APPROVED: [Signature] 1966  
 REGISTERED CIVIL ENGINEER NO. 19,683  
 DRAWN BY: [Signature]  
 CHECKED BY: [Signature]  
 CITY OF SAN BERNARDINO  
 DEPARTMENT OF ENGINEERING  
 PORTIETH STREET  
 CHANGE ORDER No. 1  
 Between Harrison Street and Mountain Avenue  
 FENCING

DEPARTMENT OF ENGINEERING  
 CITY OF SAN BERNARDINO  
 PORTIETH STREET  
 CHANGE ORDER No. 1  
 Between Harrison Street and Mountain Avenue  
 FENCING

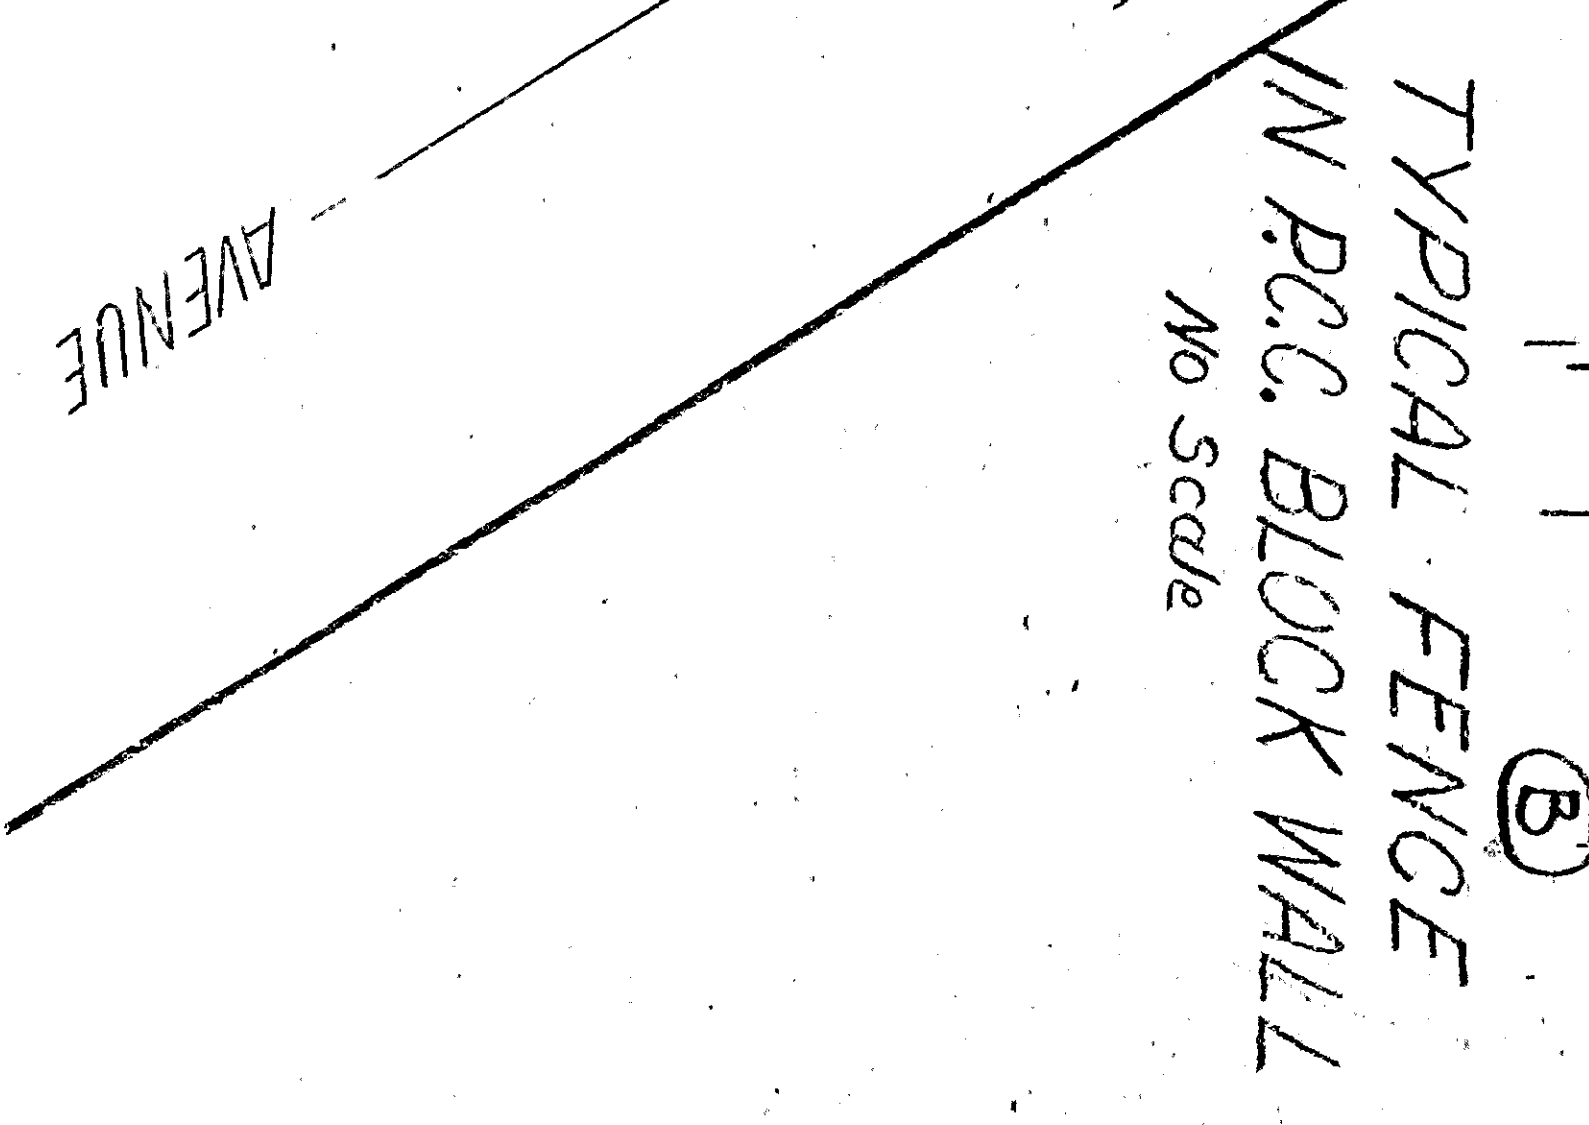
NO.	REVISION	DATE	APPROVAL
1	CHANGED FROM WELDING NEW #1 BARS TO DRAWING AND #1 ENLARGING WITH #3 BARS	7/5/66	[Signature]
2	CHANGED TOP OF CURB ELEVATION FROM 9' TO 10' STA 19157.13 TO 5' Δ 2395.63	7/5/66	[Signature]
3	REVISION	7/5/66	[Signature]

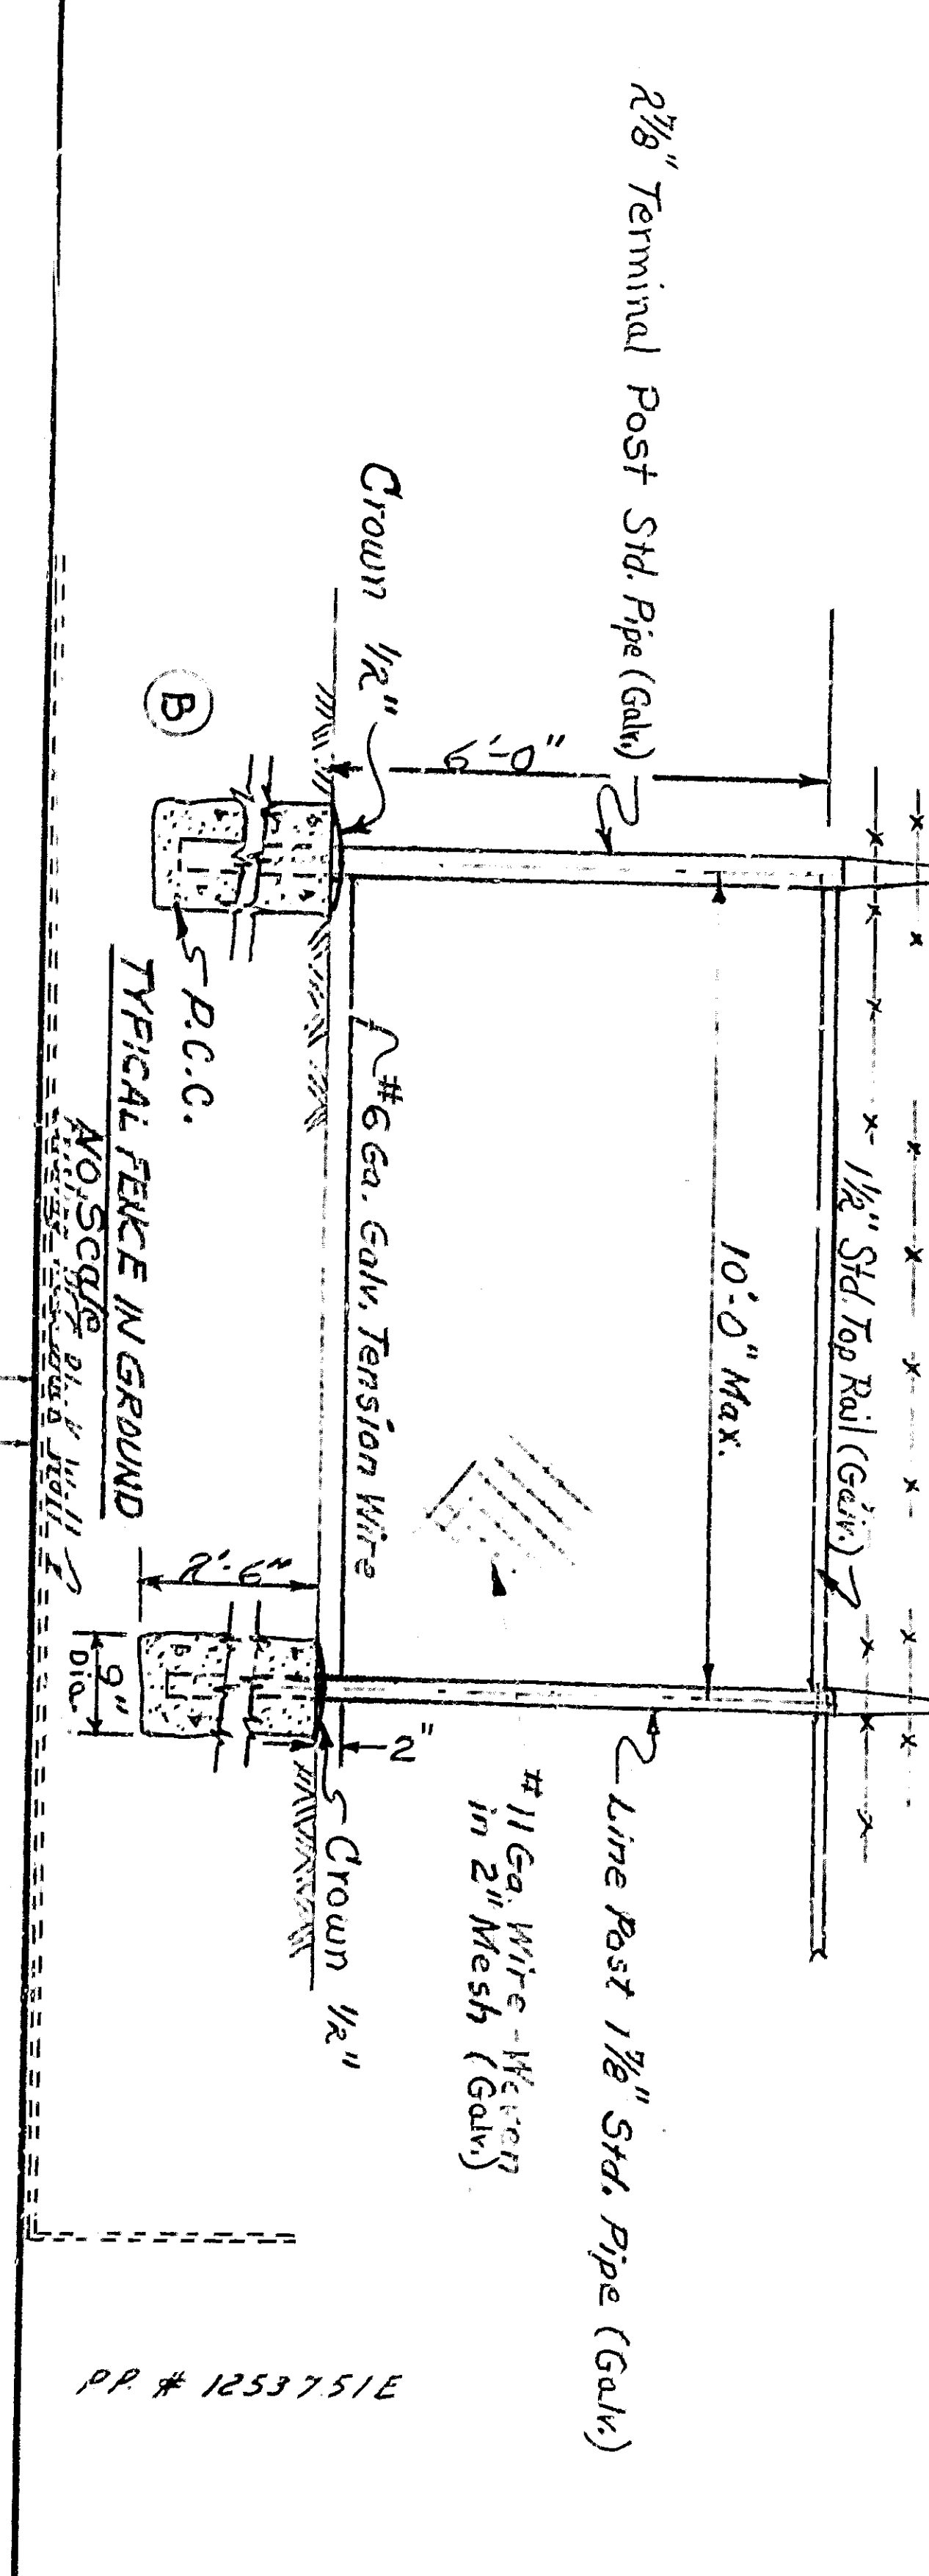
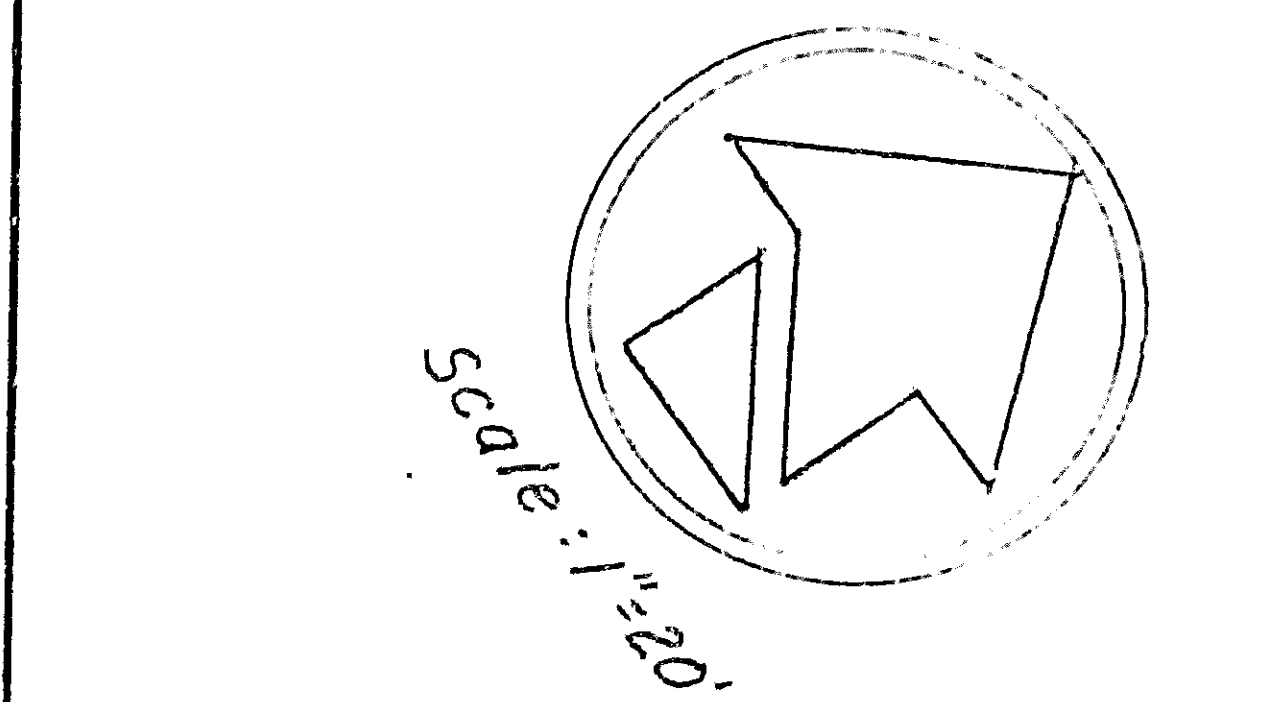
NO.	REVISION	DATE	APPROVAL
1	CHANGED FROM WELDING NEW #1 BARS TO DRAWING AND #1 ENLARGING WITH #3 BARS	7/5/66	[Signature]
2	CHANGED TOP OF CURB ELEVATION FROM 9' TO 10' STA 19157.13 TO 5' A 19157.13	7/5/66	[Signature]
